# **FINAL DRAINAGE PLAN**

## **THE RIDGE AT LORSON RANCH**

**FILING NO. 1: SF 22-004**

**JANUARY, 2022**  
**REV. MARCH, 2022**

**CORE**  
**ENGINEERING GROUP**  
15004 1ST AVENUE, S.  
DENVER, CO 80202  
PH: 719.570.1100  
CONTACT: RICHARD L. SCHINDLER, P.E.  
EMAIL: Rich@cegi.com

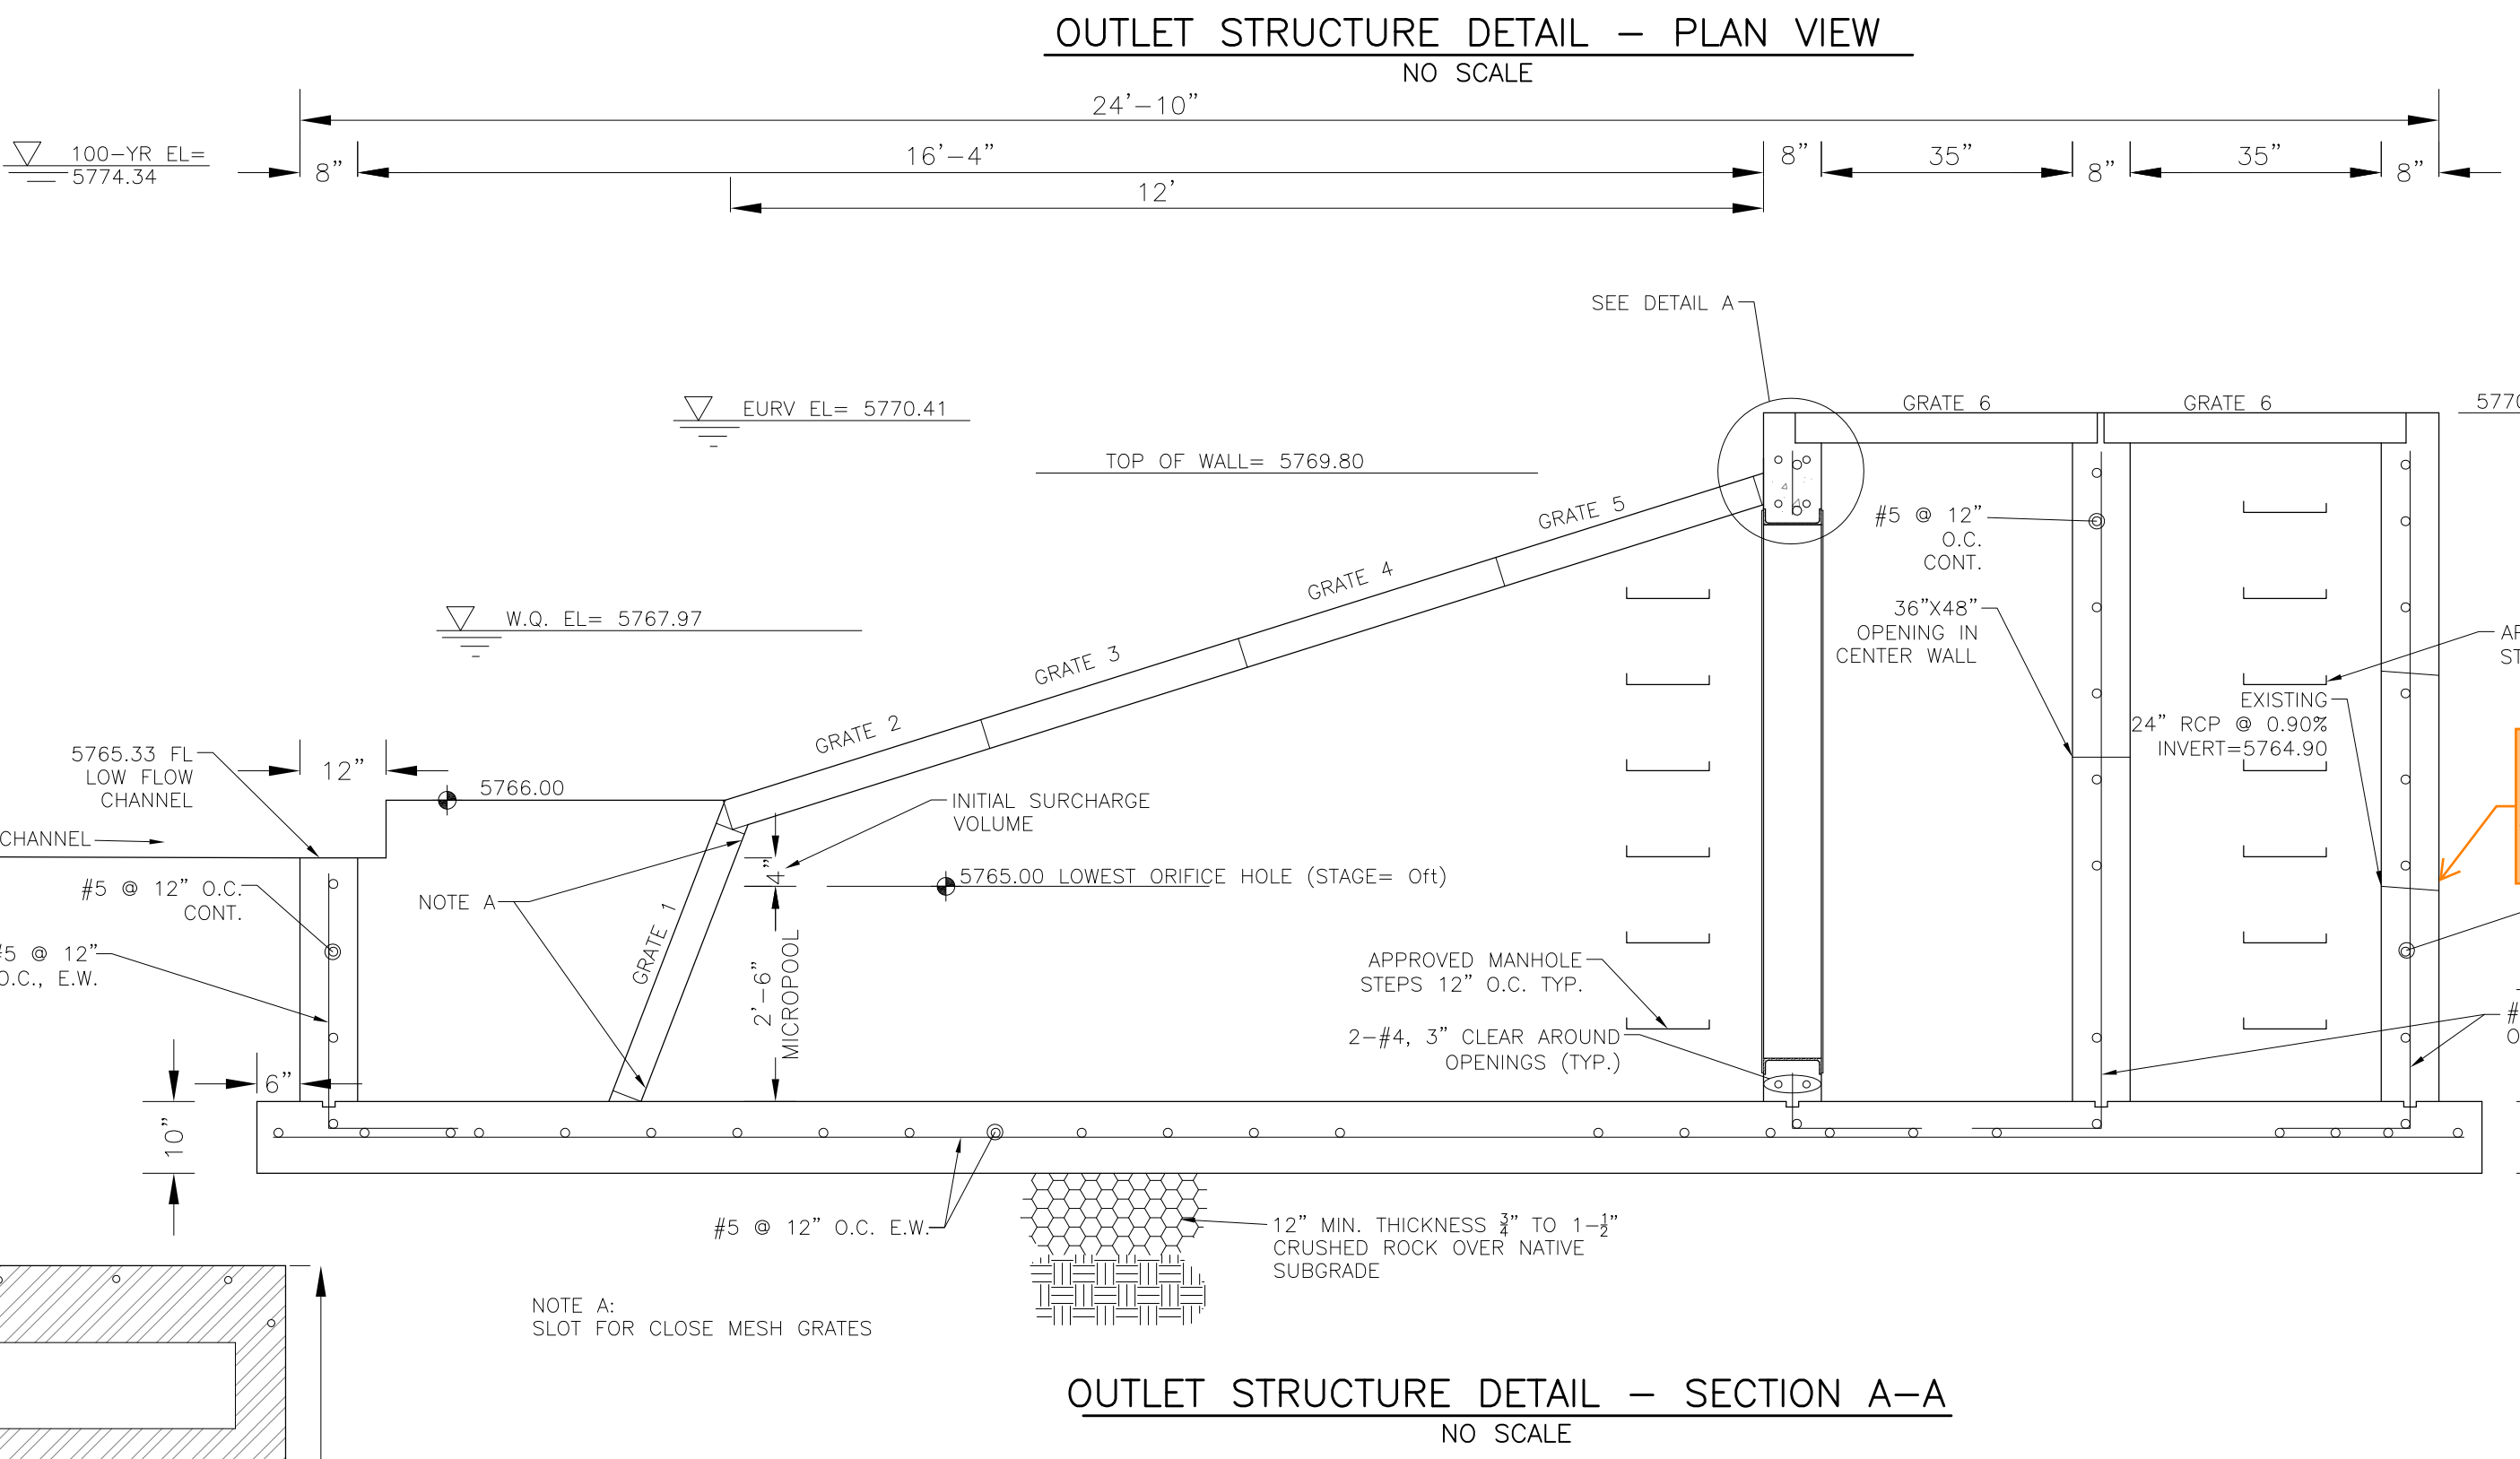
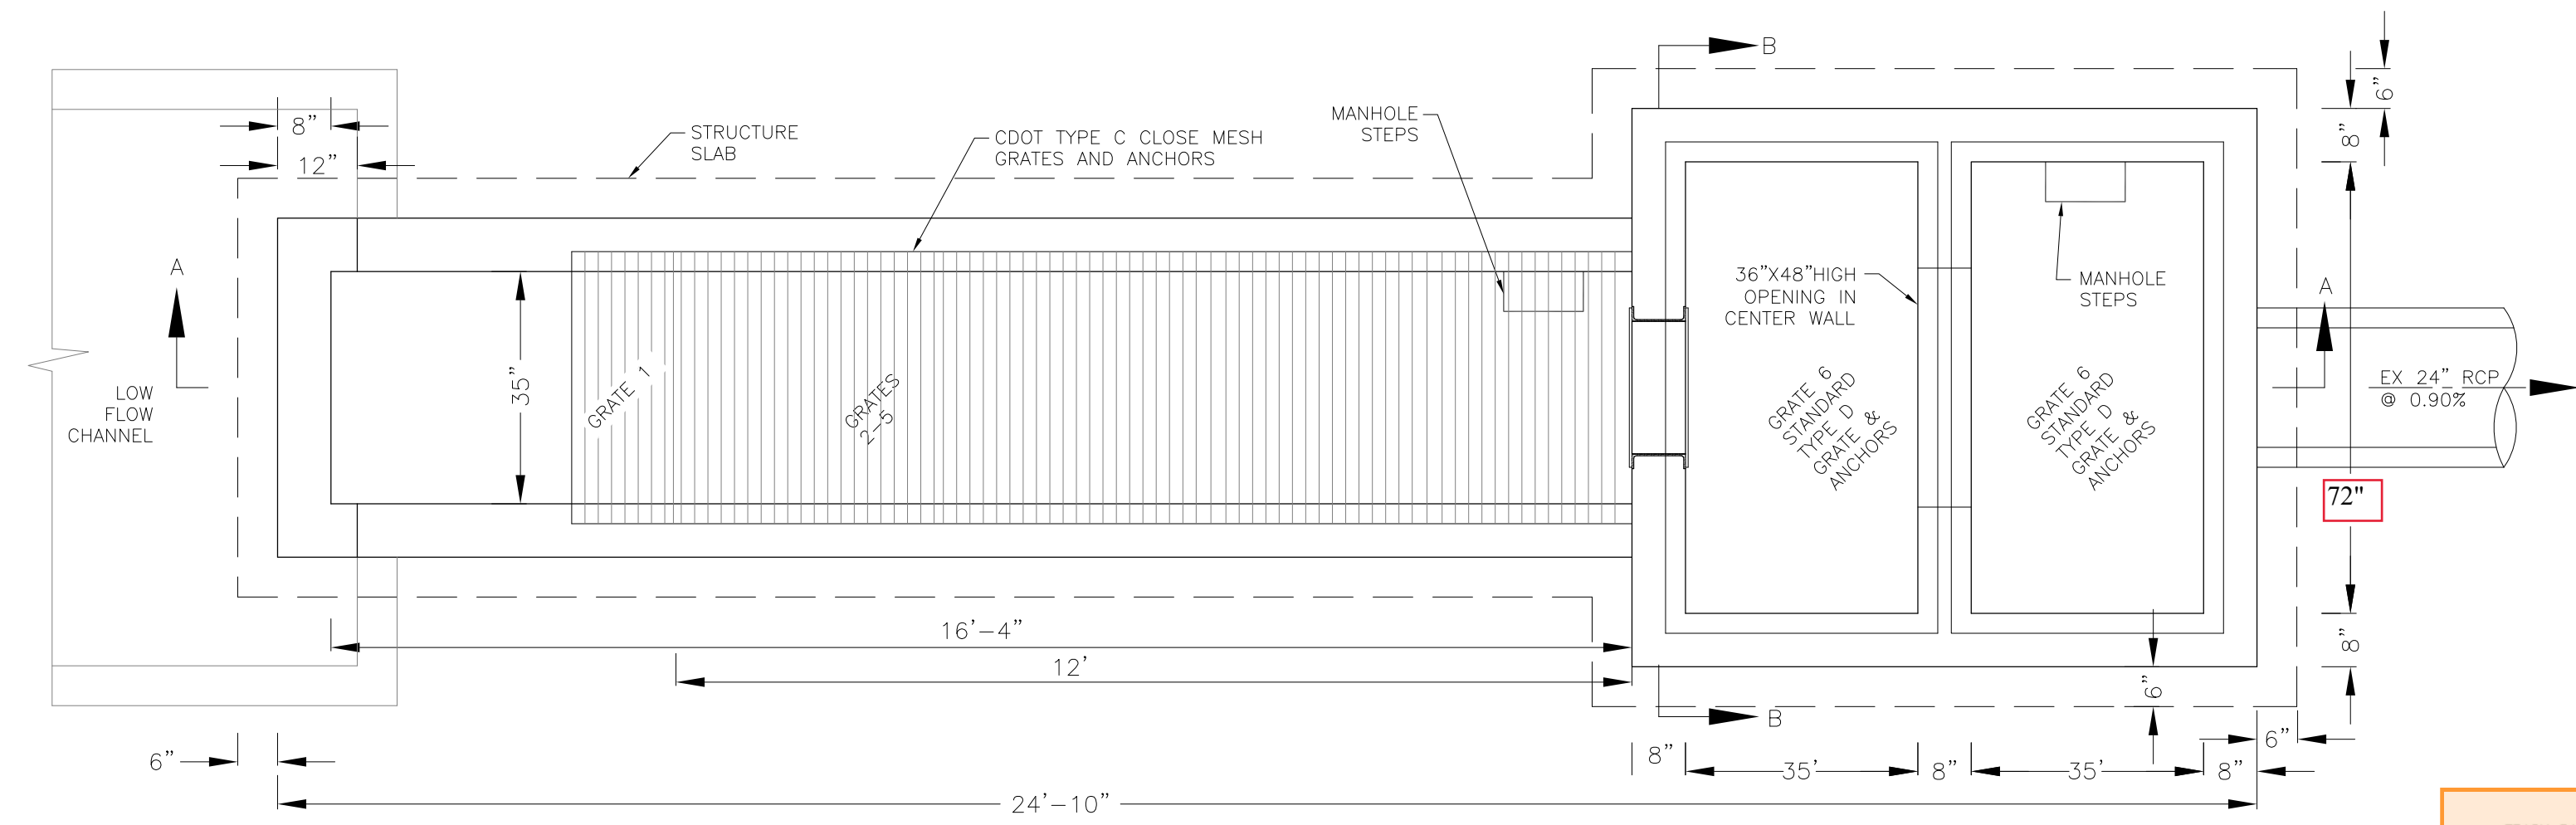
Unresolved Comment:  
Sheets C9.3, C9.4, and C9 need to be included  
in the GEC Plans or the CD's so our SW  
inspectors can see them in the field. Our SW  
inspectors do not look at drainage reports for  
drawings.
